CITY OF PORTSMOUTH  
Department of Public works

**BID #14-25 Foundry Place Parking Office Construction**

**ADDENDUM 3**

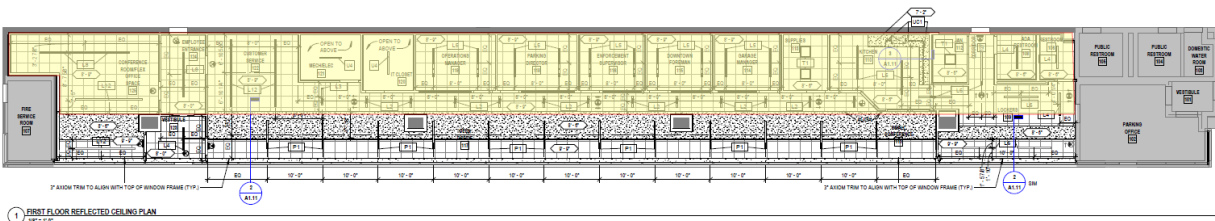
10. Drawing E1.02, keynote 1, provide a Centralized Controller, what does this mean?
11. Can the bid date be extended to November 27th?
12. Specs read "Price as alternate to provide ACT ceilings beneath concrete deck/drive aisle (plan north of column line A) Do not provide beneath metal decking (plan south of column line A)".  
These column lines are not on the RCP - what plan will show this alternate clearly?

13. See highlighted area below that this alternate refers to. This is an alternate to provide acoustical insulation on top of the ACT grid where it is beneath the driving surface above. We included this so we could have a price to add the insulation if we determine that the acoustics are louder than desired.
